Batch 6 and one question: where the Mirror of Erised's classroom stands; the halls' ceilings; the dungeon passage

The Architect, 14 October 2026, for Godric. Ledger lines 23 and 24, reqs 370 and 382 (docs/architect/changes.md), drawn on the castle model, version 24. Red: what changes. Q 2 taken at 3.15 am, provisional, Godric to confirm, and placed in version 24.

Q 1: inside, over the Entrance Hall, as Interiors drew it (floor 4, 1:250)

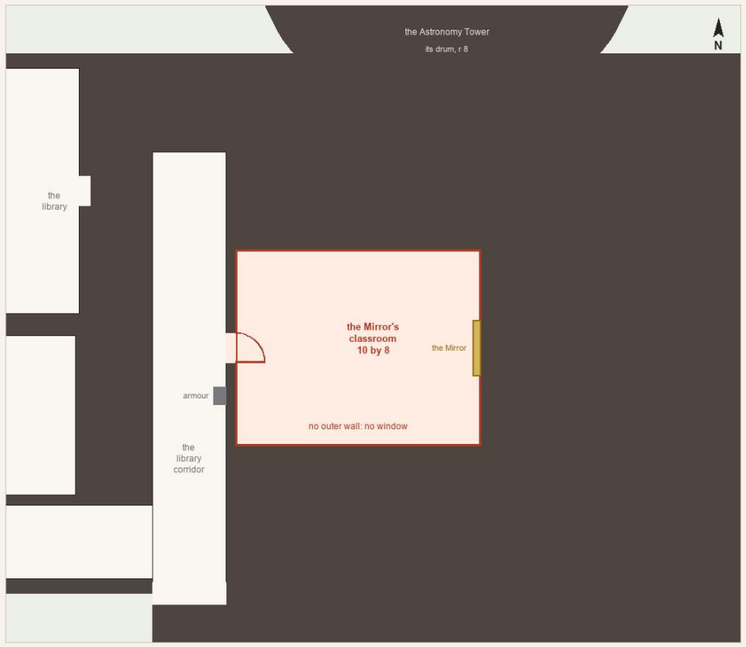
1: inside the north range over the Entrance Hall, as Interiors' key plan drew it. It meets no outer wall, so no window: the books' dark room, but the boys' day visit has no daylight and the later visit no moonlight.

Q 2: north to the tower, one window in the front wall (floor 4, 1:250)

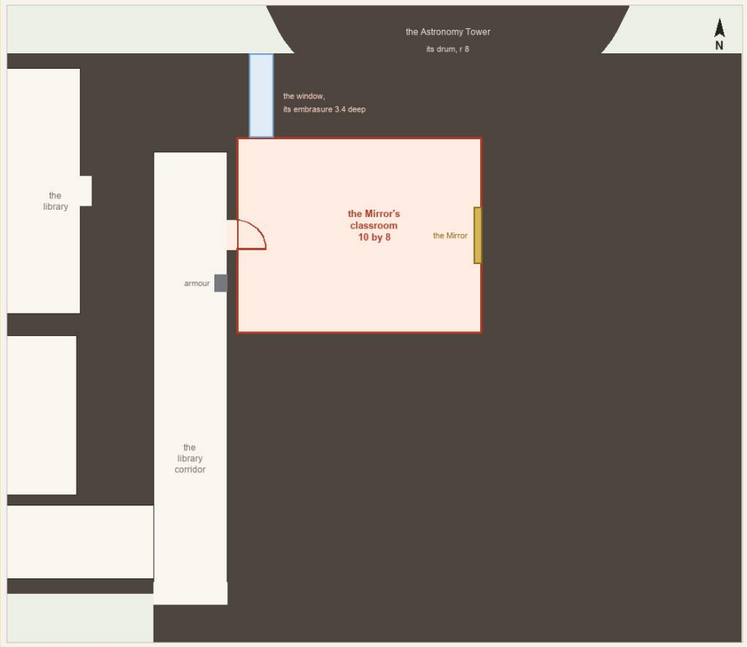
2, recommended: slid 4.6 north, its north wall against the Astronomy Tower's drum. West of the drum the front wall is free, so one window, 1.0 wide, sill 1.2, goes through it in a deep embrasure at the door end of the left wall: the light falls along the room onto the glass, never behind it or facing it. Day first, moonlight later, as Magic's thread asks.
